Flight Procedure Tracking Form		Action: FLIGHT CHECK	Task Type: IAP	Date Open: 11/16/2015	Task #: 2014103113170901001	Request #: 20141031131709
Procedure: RNAV (GPS) RWY 30L ORIG			Airport ID: KBFL	Airport: MEADOWS FIELD		Reimbursable #: NO
City: BAKERSFIELD	ST: CA	GPS #:	Estimated Chart Date: 04/27/2017		FICO #: 1179637	
Fac ID: N/A		Fac. Type:			Specialist: PABLO ORTIZ	
Procedure Review						
	Rec'd	Rel'd	Full Name	Comments		
Lead:	10/20/2016	02/03/2017	THOMAS KIRKPATRICK			
QA:	02/03/2017	02/03/2017	THOMAS KIRKPATRICK			
Liaison:	02/03/2017	02/03/2017	MARY MCDONALD			
Procedure Comments: ENROUTE-NON Remark Type: INFORMATION ACTIVE DATA USED FOR KBFL AIRPORT AND RUNWAYS CONTACT: STEVEN VARGAS, AJV-5421 405.954.8568 2/28/17: THIS IS A CORRECTED COPY OF THE FORM APPROVED ON 1/27/17. 1. REQUIRED EFFECTIVE DATE CHANGED FROM ROUTINE TO 04/27/2017.

FIPC BASIC FORM							
PROCEDURE: RNAV (GPS) RWY 30L ORIG			AIRPORT NAME: MEADOWS FIELD		AIRPORT ID: KBFL	SPECIAL CONTROL NO: SG-02-036-17	
FAC ID: KBFL30L		CITY: BAKERSFIELD			ST: CA	ORIG CHART DATE: 04/27/2017	
DFL TYPE: PROC/S	THIRD PARTY: <input type="checkbox"/> YES	EST. TIME ON SITE: 0.4	REIMB. NUMBER: AC0598		PTS TASK ID: 20141031131

AUTOMATED AL-36 RNAV (GPS) RWY 30L
AUTOMATED AL-36 RNAV (GPS) RWY 30L
AUTOMATED AL-36 RNAV (GPS) RWY 30L

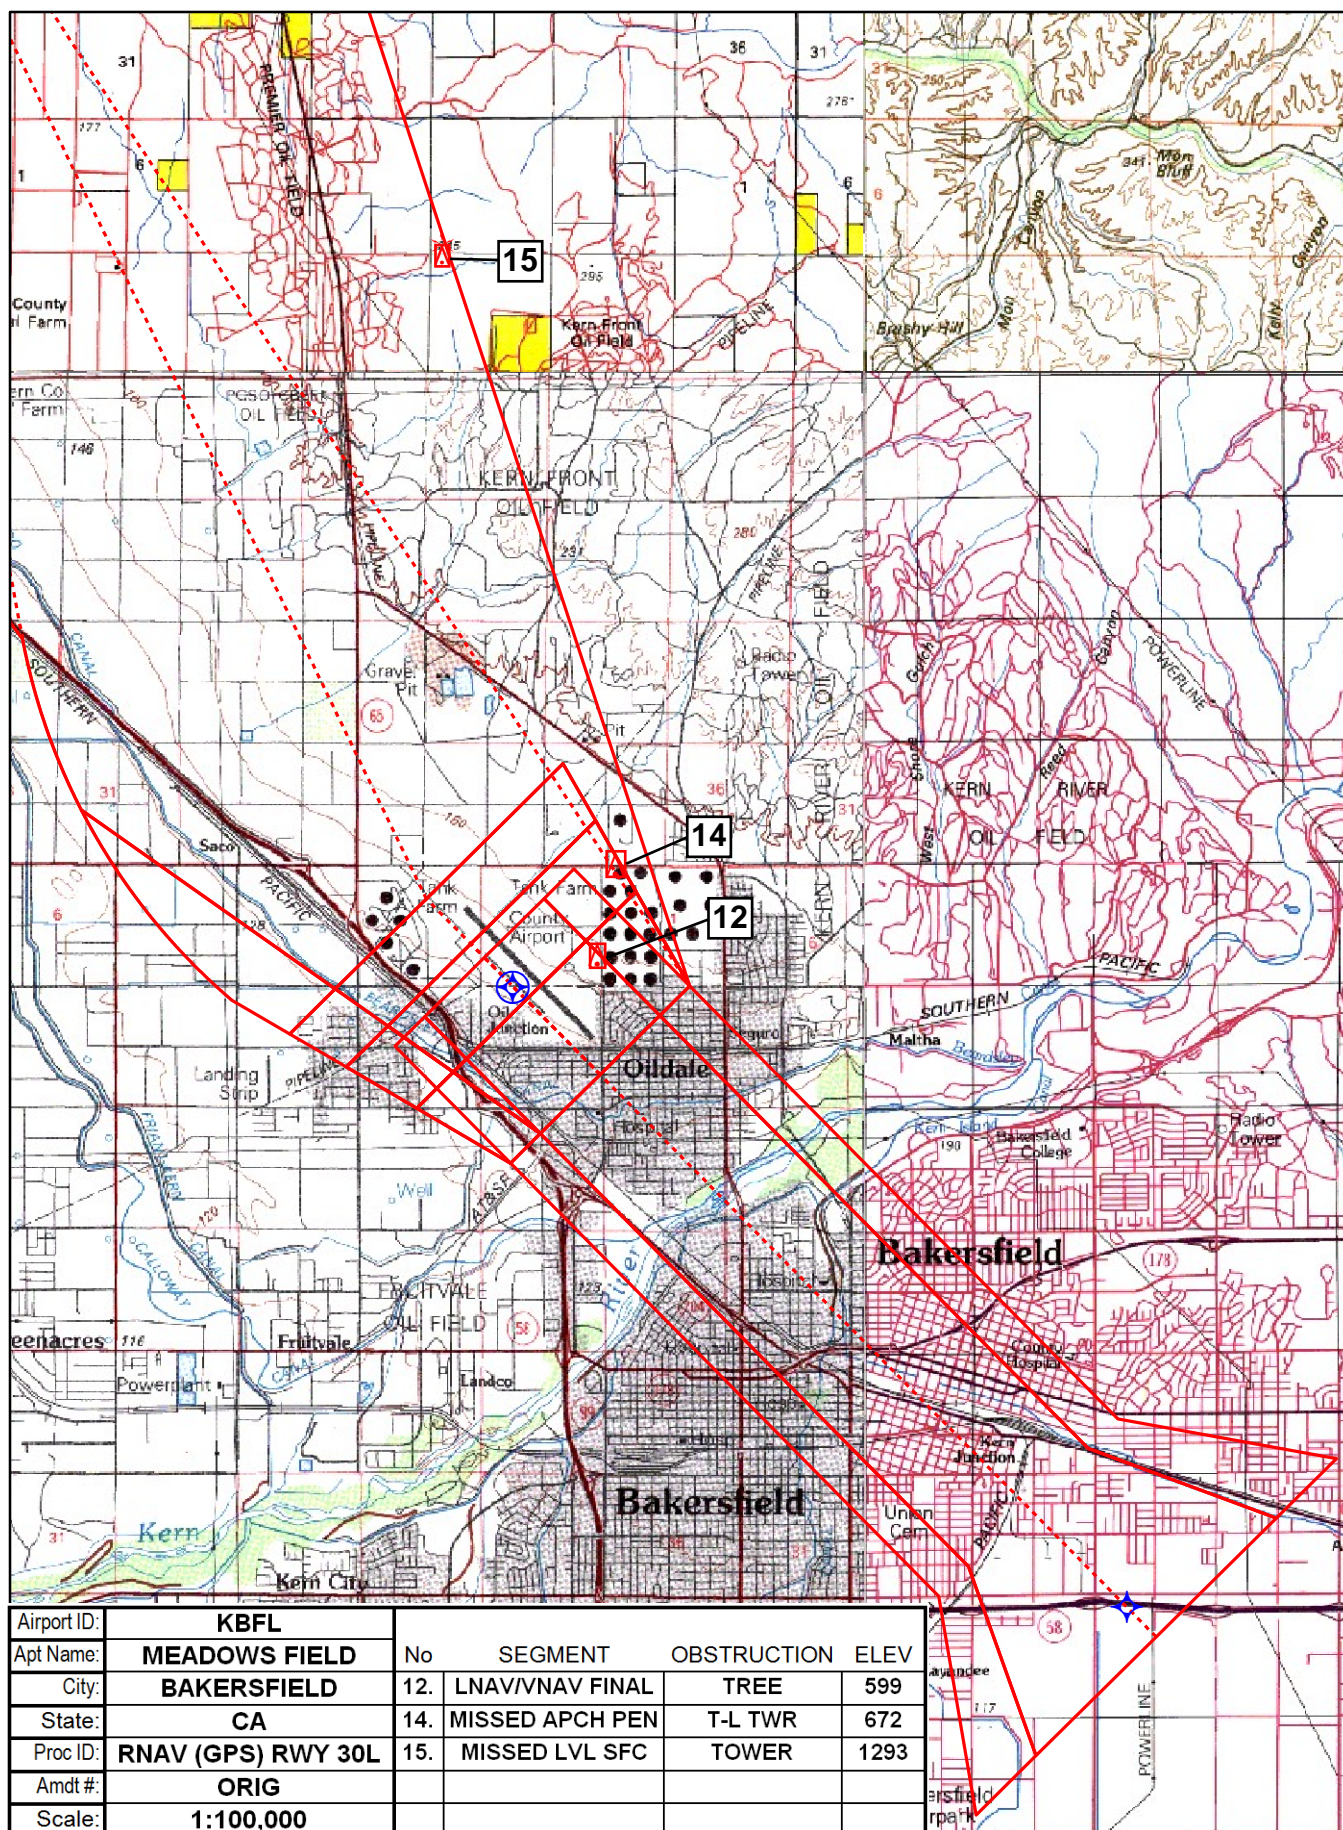
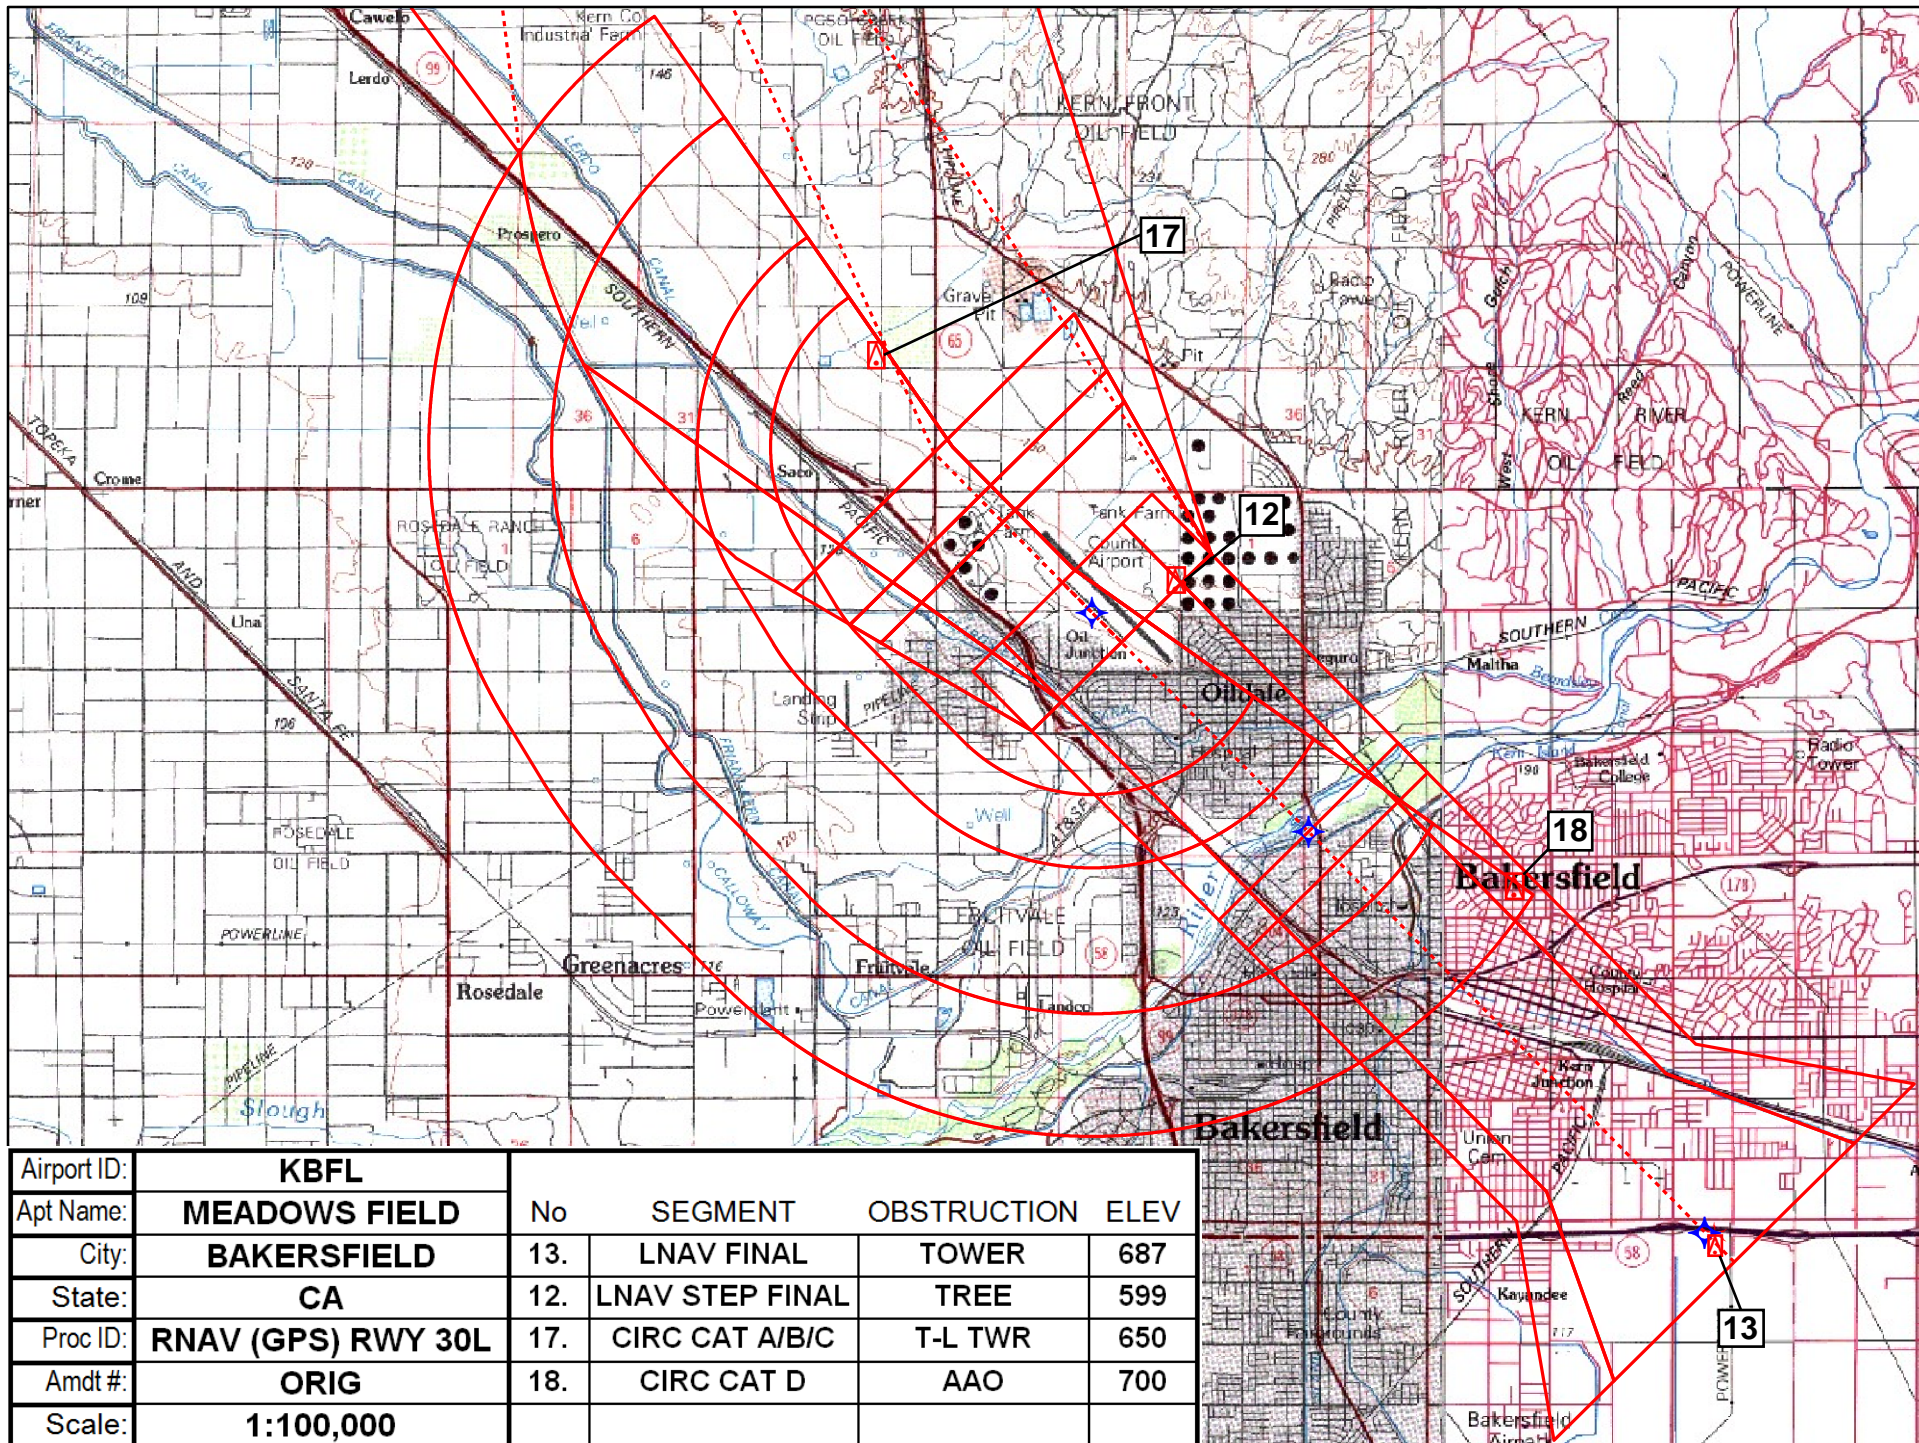
FLIGHT INSPECTOR REMARKS: RWY 30L This shows what the Universal box displayed the runway as ,and what those coordinates were. It should go from FAF to RWY30L with runway coordinates near N35 25' 52.3020" W 119 03' 23.4250". It is Unsat because the FAF to RWY coding is incorrect. It showed RWY18 at 1595 nm (N33 34.39' W086 44.83').							
IN-FLIGHT OBSTACLE REPORT							
OBSTRUCTION ID #:	COORDINATES OR LOCATION:		GNSS ALTITUDE (MSL):		BAROMETRIC ALTITUDE (MSL):		HEIGHT ABOVE GROUND LEVEL:
